Certificate of Appropriateness
BAR # HST26-0006
554 Valley Road; TMP 110053200
Oakhurst Circle-Gildersleeve Wood ADC District
Owners/Applicants: Lindsay & Evan Edwards
Project: Addition on front elevation

**City of Charlottesville
Board of Architectural Review
Staff Report
March 17, 2026**

Project: Addition on front elevation with alterations

Demo Plan Floor 1	
Project number	AD101
Date	
EDWARDS	
554 VALLEY DRIVE	
Scale 1/4" = 1'-0"

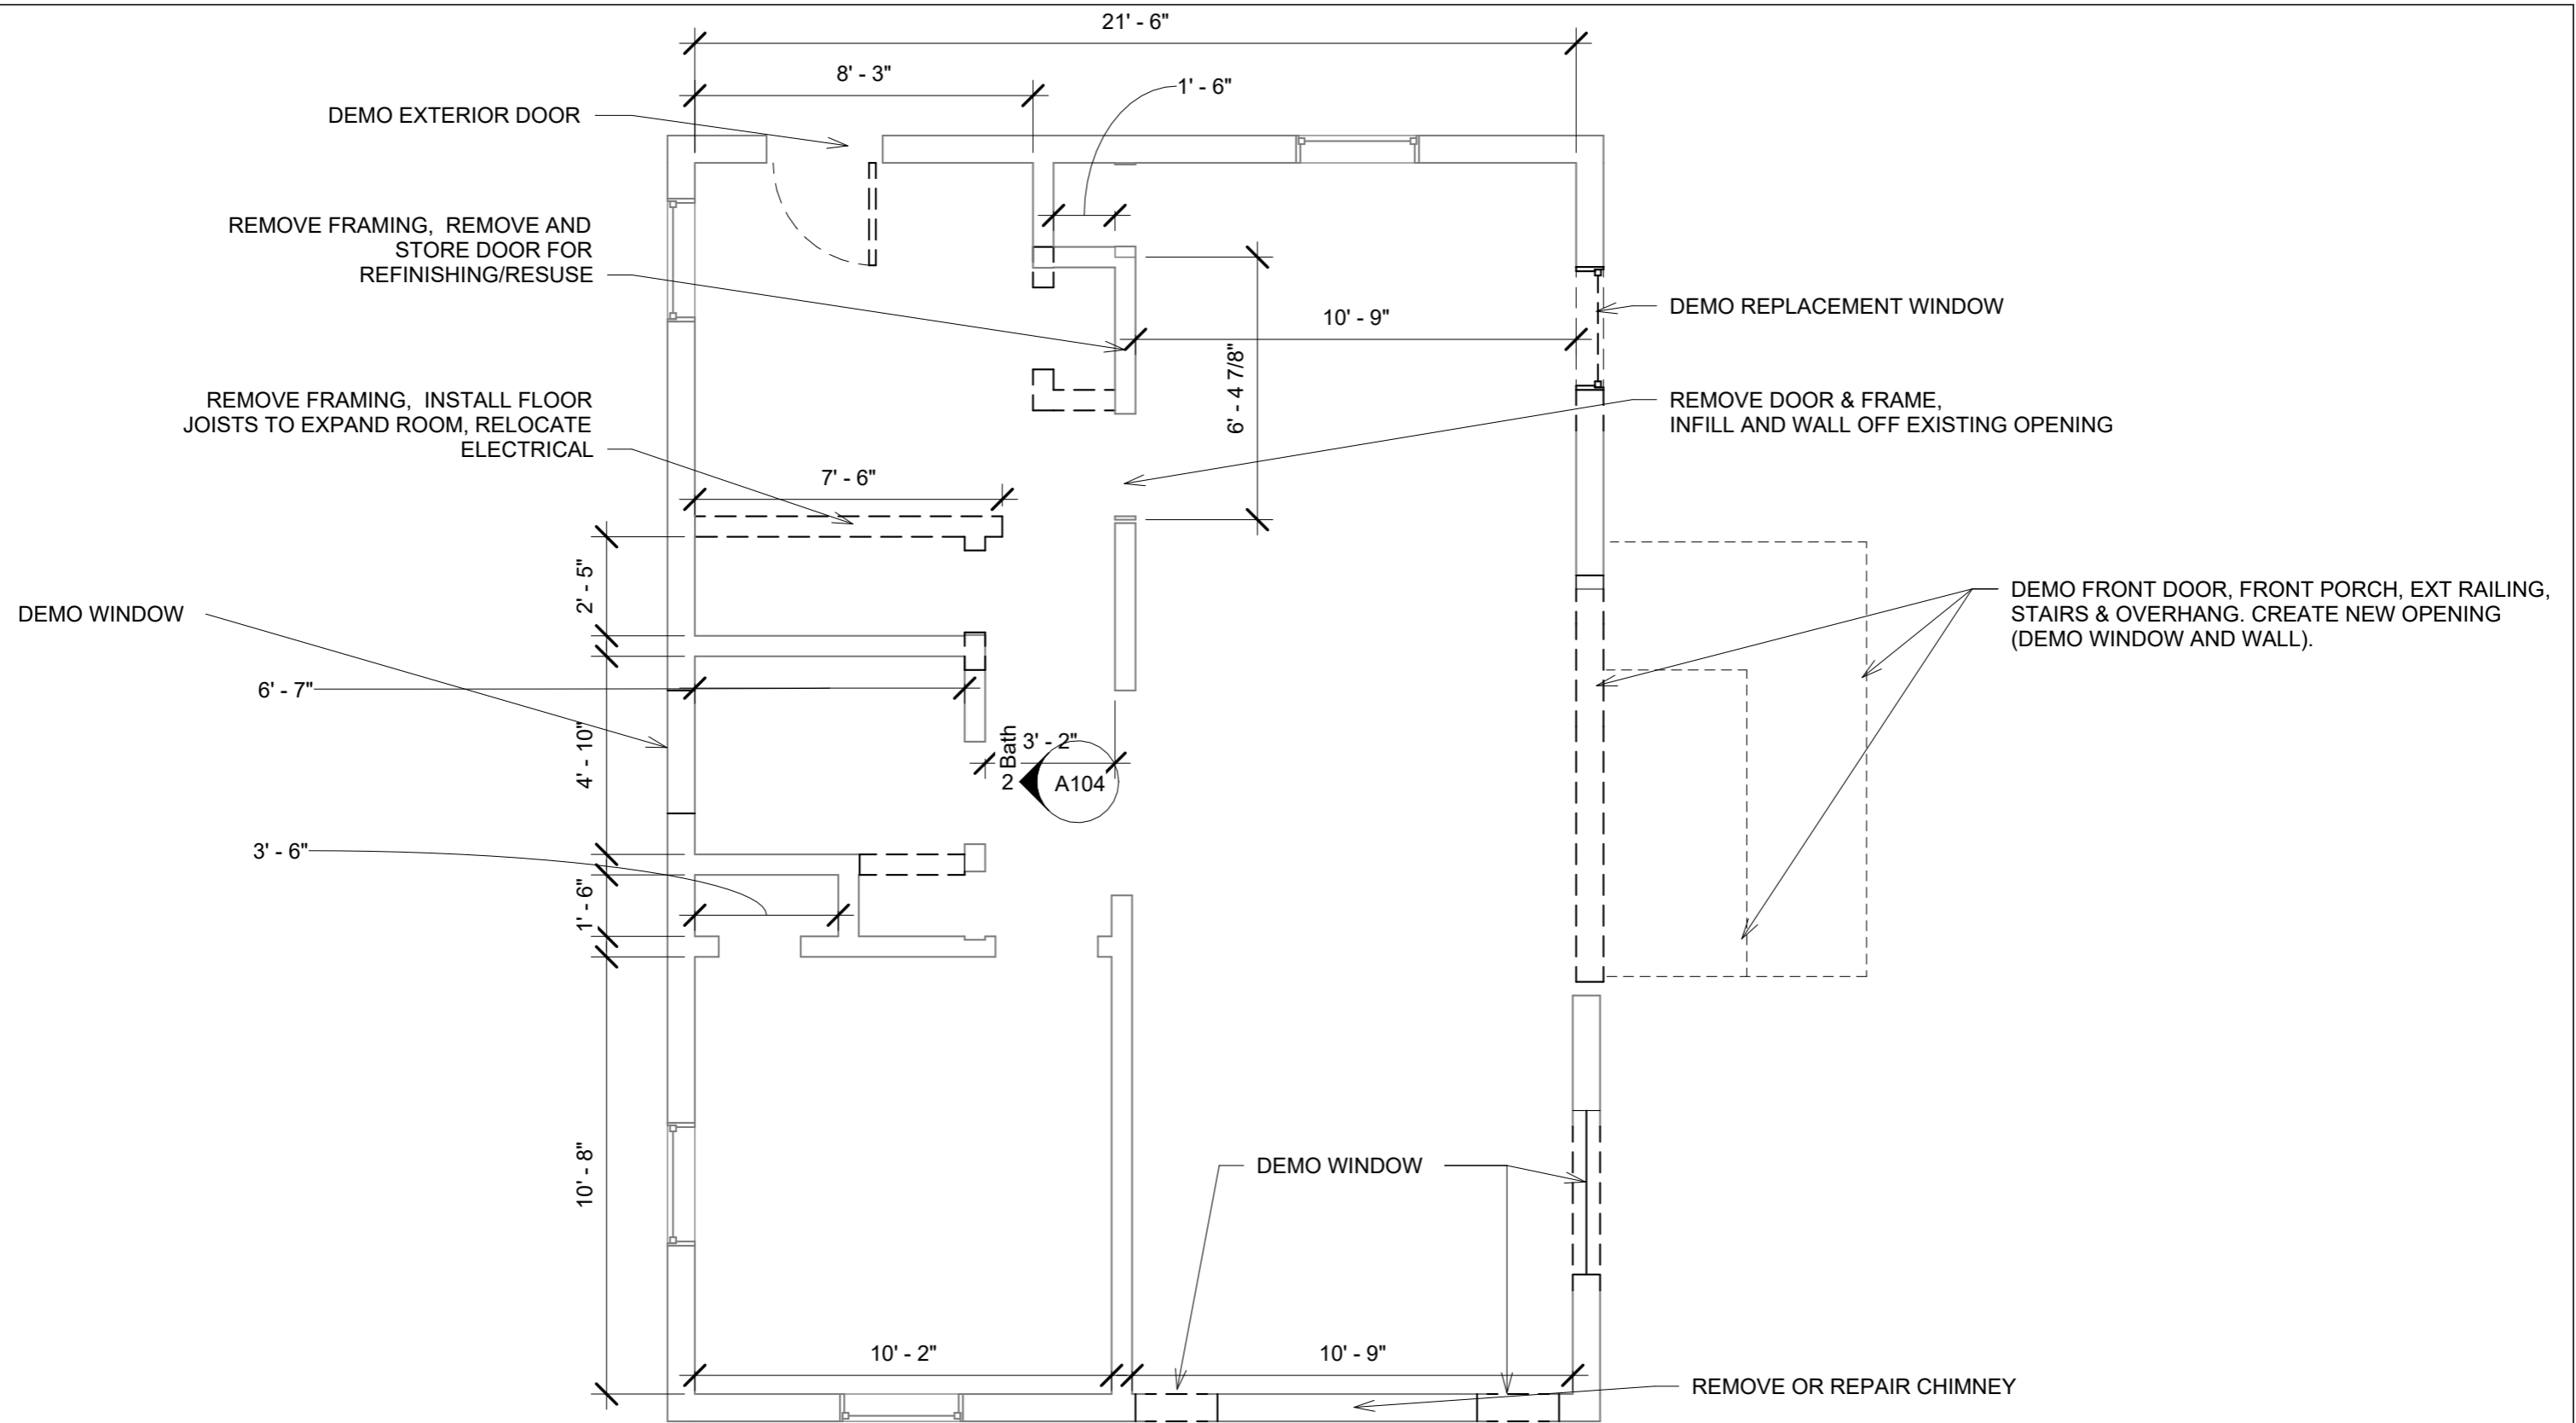
- The garage doors be retained and stored on-site.
- The window and door trim be installed flush with or slightly proud from the stucco; Windows in the stone wall should be recessed.
- New gutters should be half round
- The standing-seam metal roof should be replaced in kind. The Design Guidelines make this recommendation: *Avoid replacing a standing-seam metal roof with asphalt shingles.*
- Note on Sheet AD101: *Remove or repair chimney.* BAR should require it be retained.

- The garage doors be retained and stored on-site.
- The window and door trim be installed flush with or slightly proud from the stucco; Windows in the stone wall should be recessed.
- New gutters should be half round
- The standing-seam metal roof should be replaced in kind
- The existing chimney will be retained.

3 Section 3
1/4" = 1'-0"

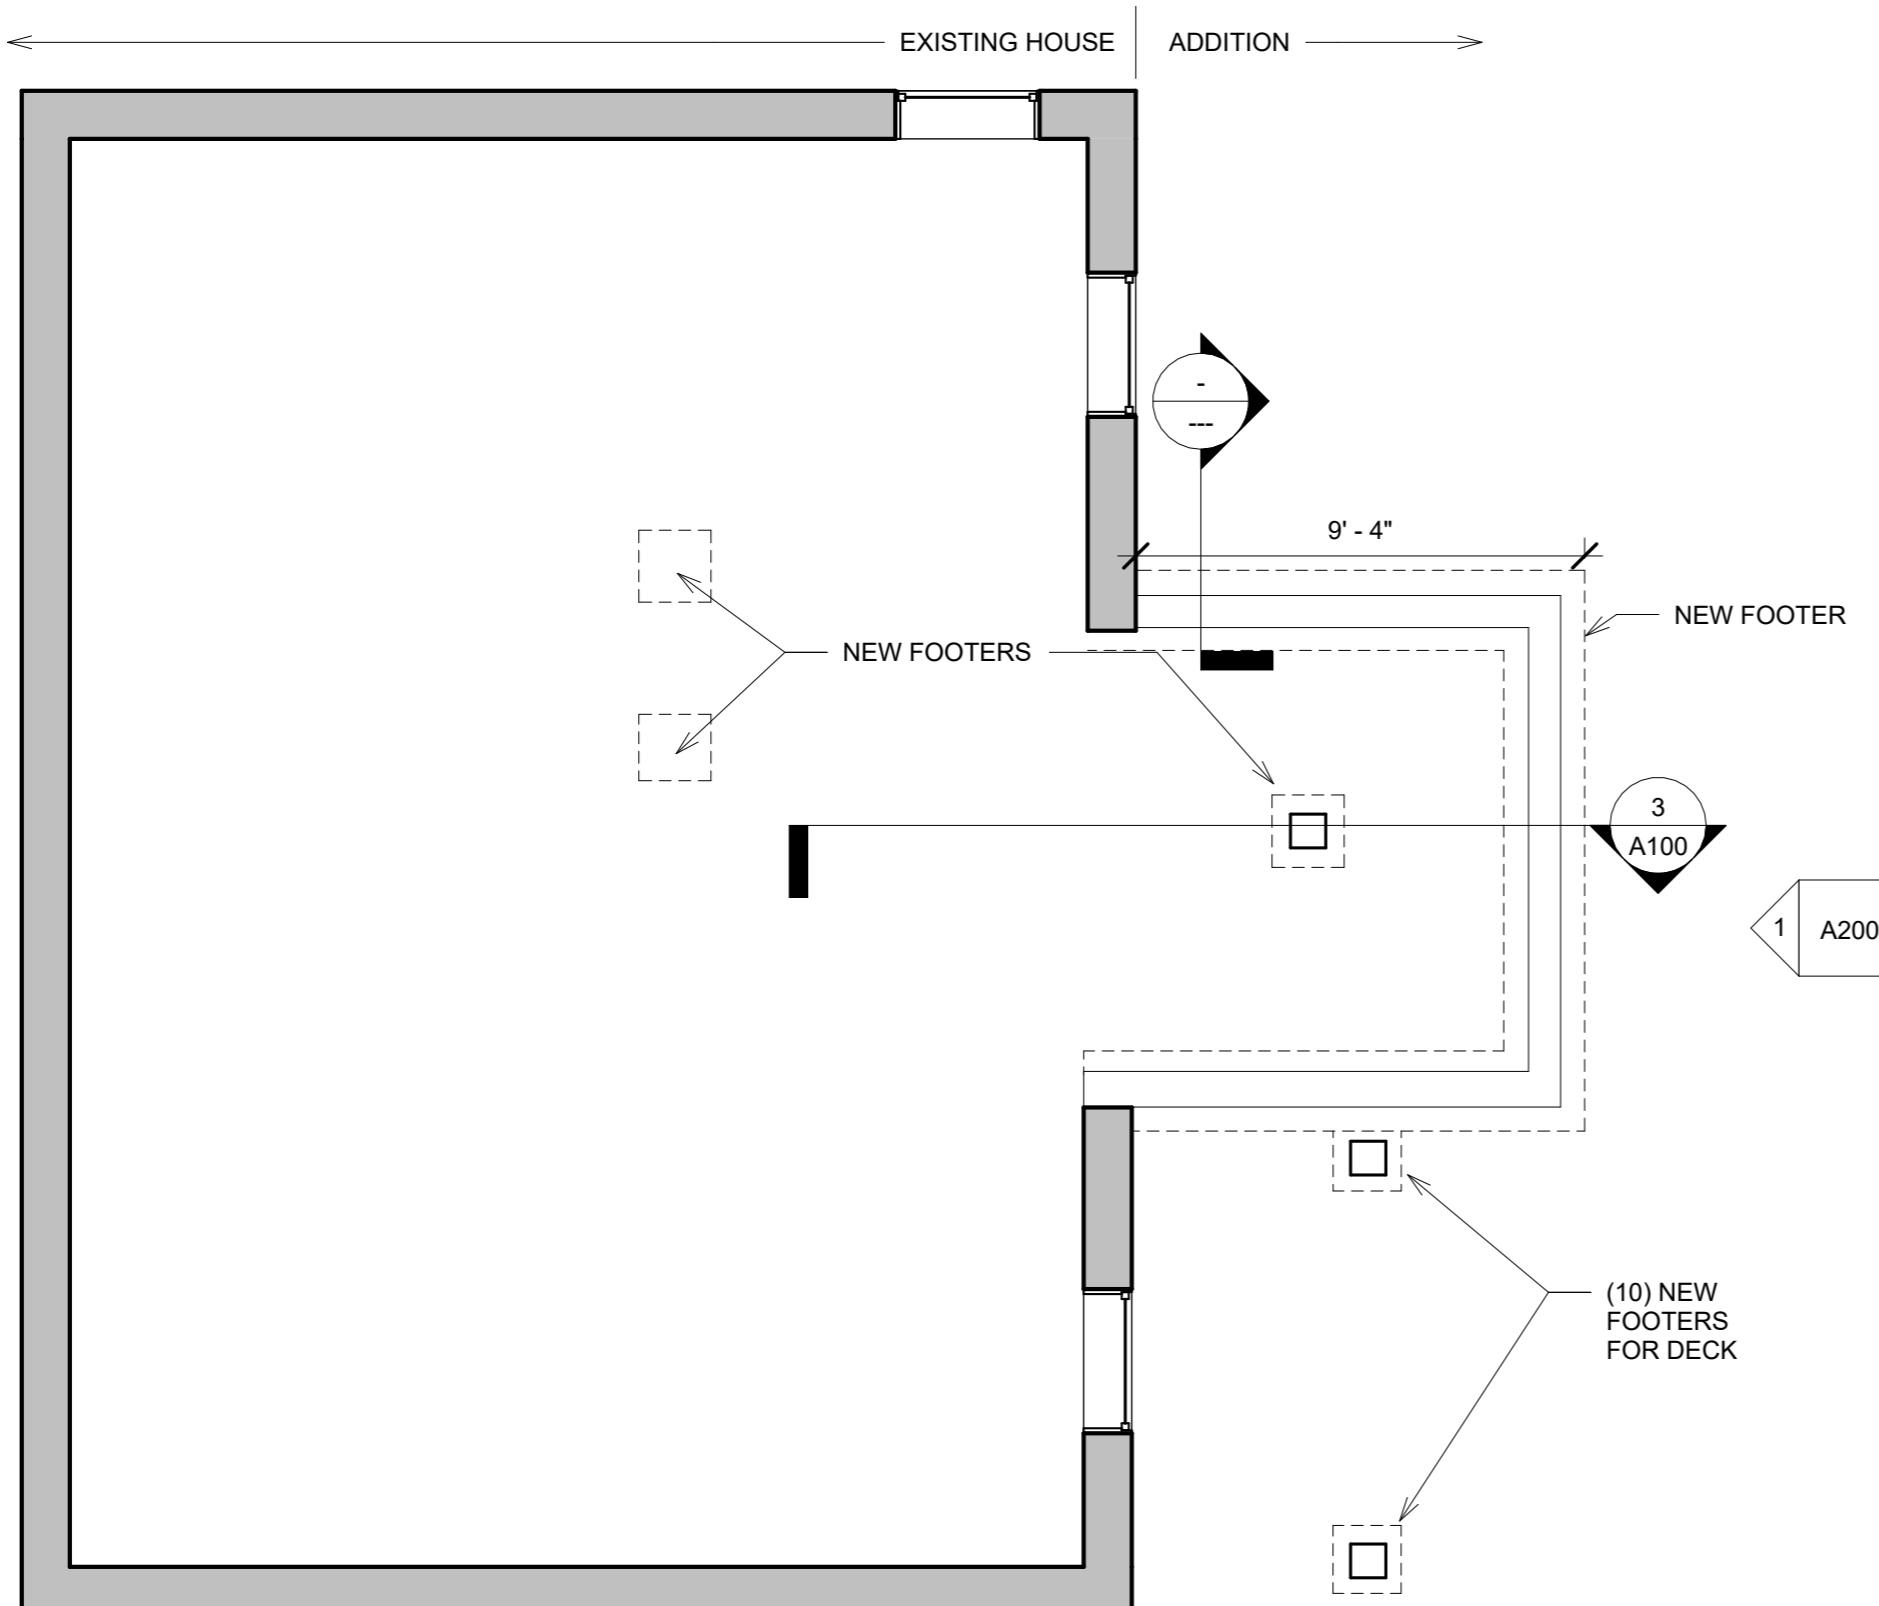
- *Request: Exterior elevations and/or section of the addition (currently we have a front elevation, and interior plan).*

Response: Please find updated A200 with all elevations. Also, there is a section provided of the addition on 3/A100.

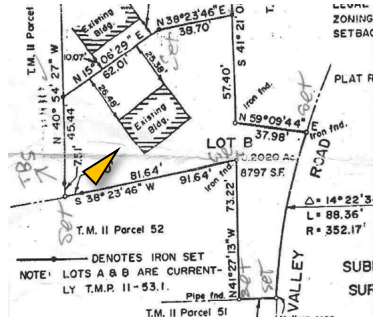
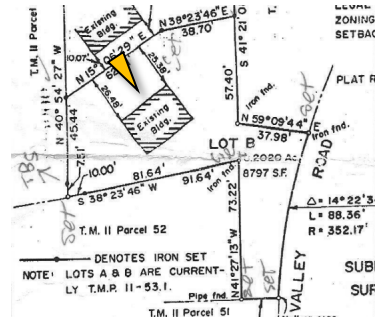
- *Request: Scope of work includes roof replacement and chimney repair/capping... need images of existing conditions.*

Response: Please find images of existing brick chimney below. Existing chimney is cracked and listing. Masonry repair, repointing , and new cap will be provided.

Main Level Front Window Replacement:

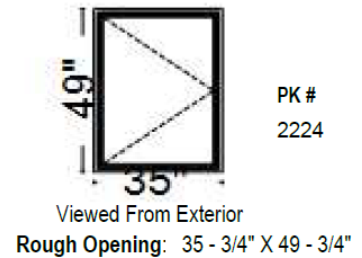
- *Request: Materials/spec sheets selected for: roof (*asphalt proposed to replace metal), gutters, exterior trim, exterior treatments (stone to match existing/stucco), windows, door, stair details and railings (Trex and aluminum)*

Windows: The previous owners of the property replaced the two windows at the front of the house on the upper level with cheap vinyl windows that are not in keeping with the historic elements of the house. This renovation will replace 2 of those vinyl windows on the upper floor with double casement windows (see attached cut sheet from Pella) that are more in keeping with the historic windows at the house. The middle vinyl window will be removed as part of the new opening for the addition at the front of the house. The lower level windows will be replaced by single casement windows to create a visual hierarchy of the two levels. The windows on the basement level will need to be larger than the existing windows in
